Remarks

Application Serial No.: 09/450,802
Title: Method And System For Source Synchronous Sampling
ANNOTATED SHEET SHOWING CHANGES

FIGURE 2

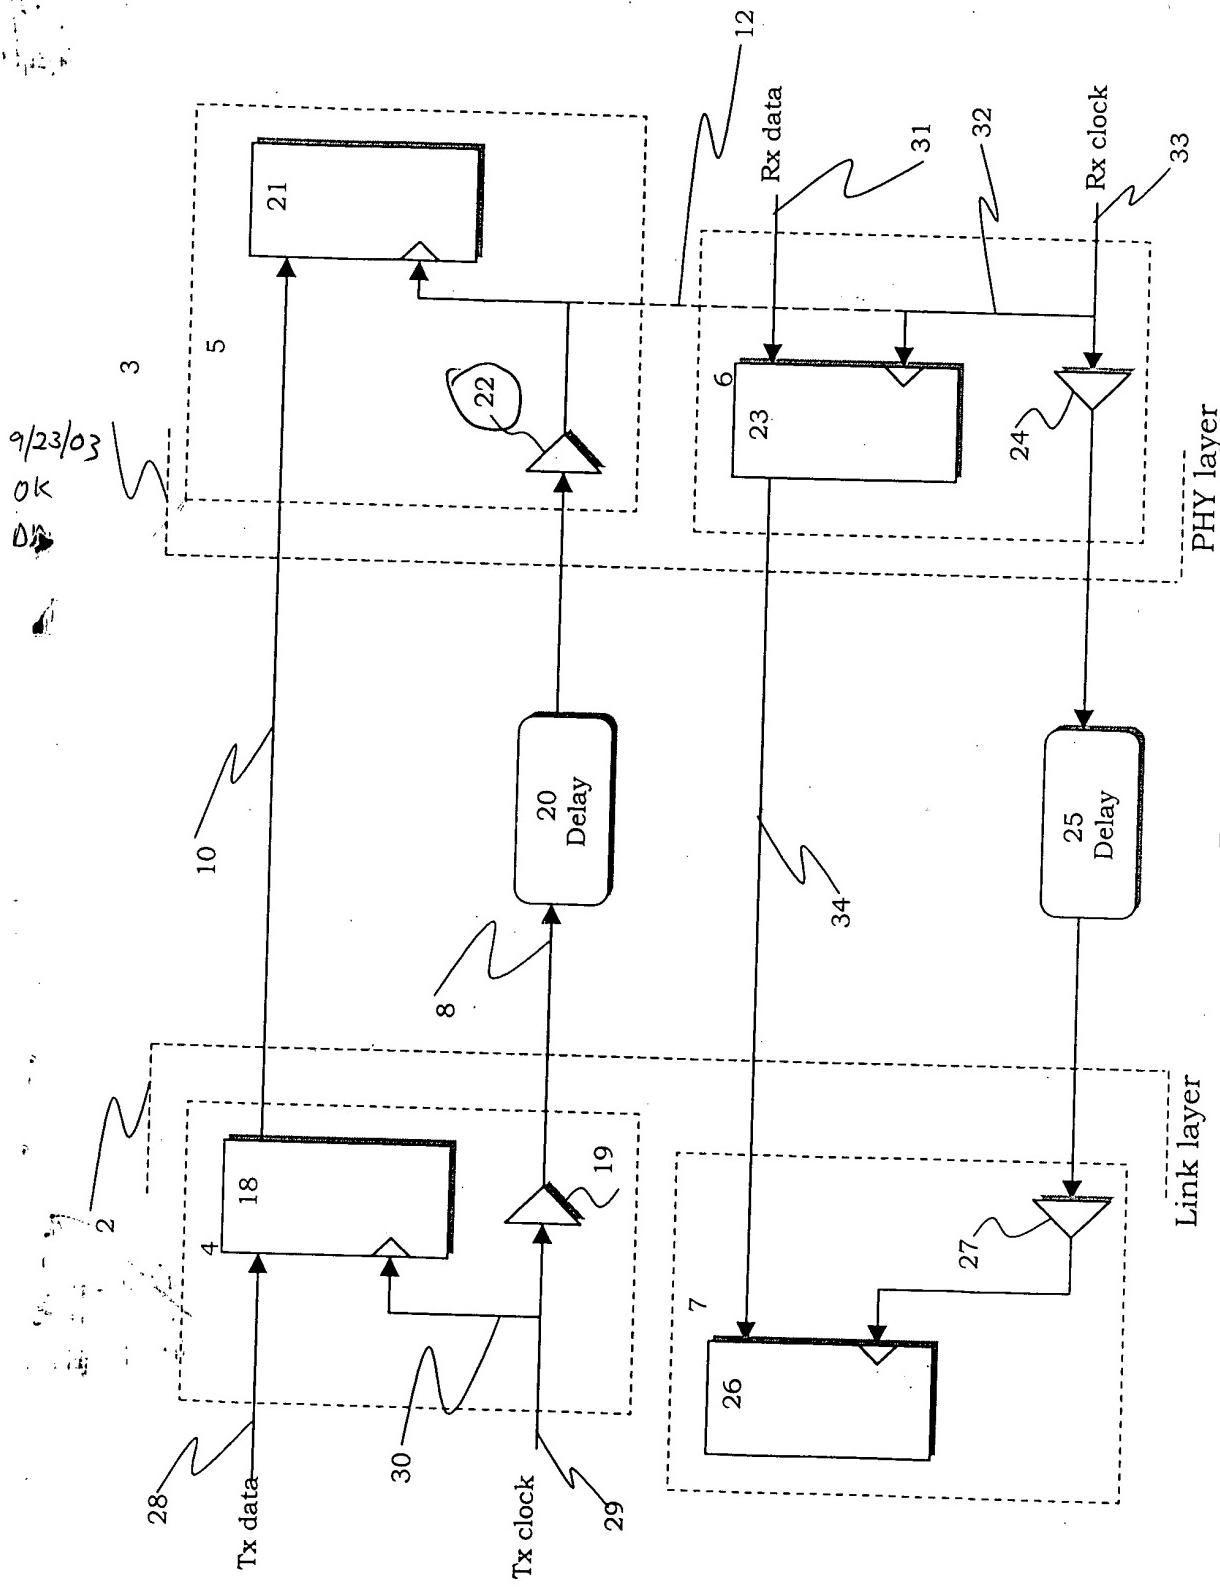
The drawings are objected to because the reference character **23** has been used to designate both a buffer and a register in **Figure 2**. **Figure 2** has been amended to correct this error as shown in the attached appendix. No new matter has been added.
